UNITED STATES PATENT AND TRADEMARK OFFICE

10/575,860

Office Action Summary	Application No. 10/575,860	Applicant(s) KIM, KYU YOUNG	
	Examiner PHILIP H. LEUNG	Art Unit 3742

DETAILED ACTION

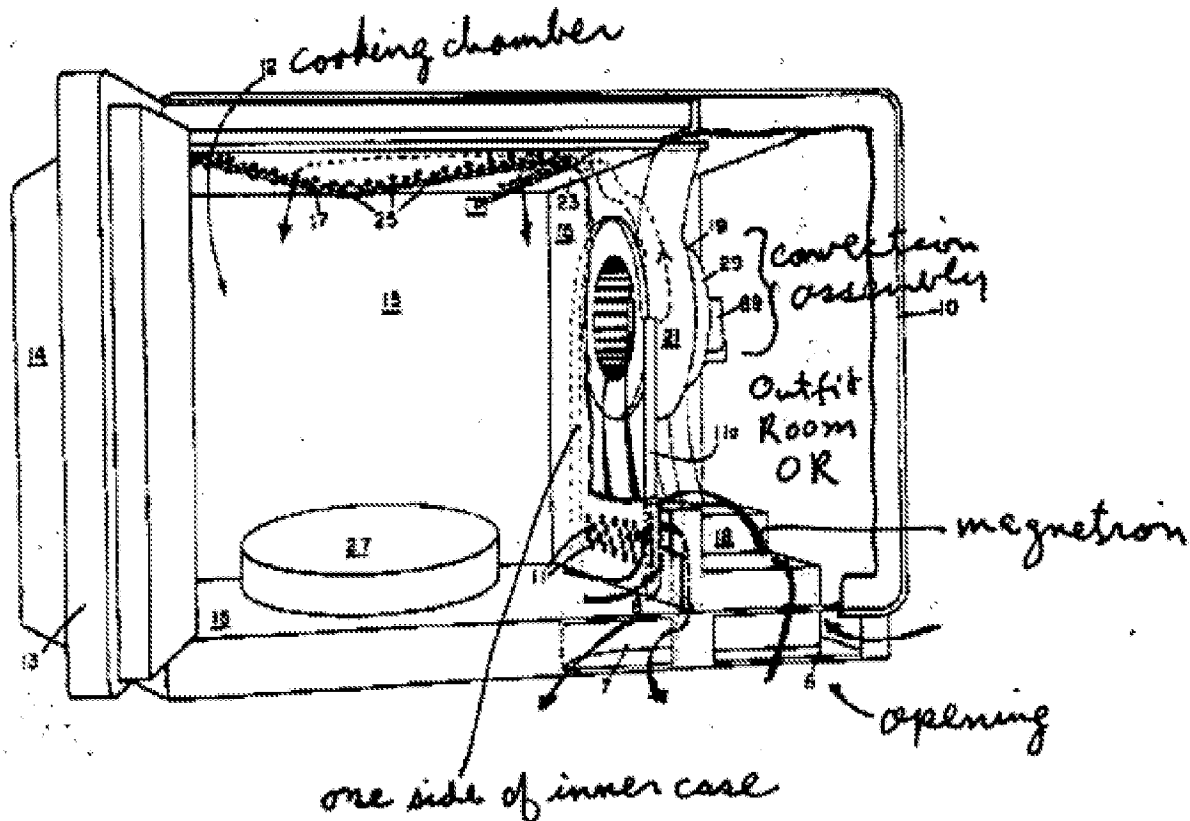
Larsen shows a microwave oven comprising: a body 10 forming an outer appearance; an inner case 15 in the body having a cooking chamber 12 formed therein; an outfit room (marked as OR) at one side of the inner case, having various electric parts, (including a magnetron 18, a high voltage transformer 92), mounted therein; and a convection assembly (19, 21, 29) mounted at a side of the inner case, for transmitting heat to the cooking chamber and a convection heater 17 for generating heat for convection heating (see the marked-up copy of Figure 1 below).

As set forth above, Larsen shows every feature as claimed except for the location of the convection heater 17. Tanaka shows a microwave oven having a convection assembly chamber 20 located adjacent to the inner casing with a cooking chamber 2. A convection assembly including a convection fan 17 surrounded by a ring shaped heater 15 as a convection heating element for convection heating of food items 31 in the microwave cooking chamber (see Figures 1-3 and 6-9 and col. 3, line 32 – col. 4, line 15). It would have been obvious to an ordinary skill in the art at the time of invention to modify Larsen to locate a convection heater surrounding the convection fan so that the heated air can be directed forced into the cooking chamber for more efficient and better cooking result, in view of the teaching of Tanaka. In regard to claim 26, the use of temperature sensors in a microwave convection combination is well known. For instance, Larsen teaches the use of a temperature sensing system 30 (see col. 4, lines 1-9) and Tanaka uses
